Saffron Walden Town Council Response Regarding the Green Mile POS

Section 62A Planning Application: S62A/2022/0014 Land west of Thaxted Road, Saffron Walden

The application proposes installation of a footway to Tukes Way and shared footway and cycle way link to Peal Road both from the application site, illustrated in the Addendum Travel Assessment Appendix 15. (Extract below.)

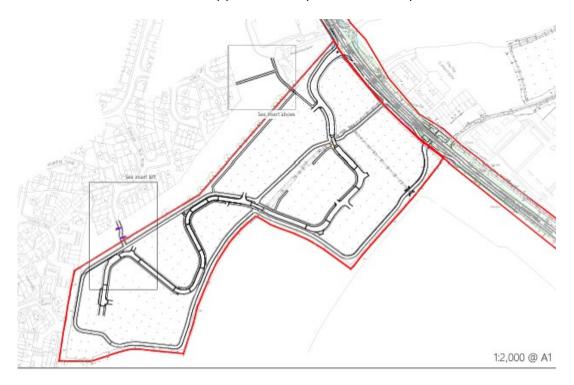
These proposed linkages are not possible without being installed across the existing POS known as the Green Mile.

SWTC objects to installation of paths across the Green Mile because it would subdivide this well-used POS. Installation of a path across POS would change the nature of the area and users would have to be vigilant and aware pedestrians and cyclists who would use the path as a through route, the nature of the Green Mile therefore will no longer be publicly available amenity POS.

Whilst SWTC understand sustainable transport methods are a requirement, this should not be at the cost of losing much needed POS in an adjacent area. The loss of POS when there is an existing deficit of POS in Saffron Walden would cause significant harm to residents and users.

Building on the Green Mile would therefore reduces the publicly available open space and changes its usage dramatically and for this reason SWTC objects to installing paths across it. The application therefore cannot demonstrate sustainability and connectivity and SWTC continues to object to the application.
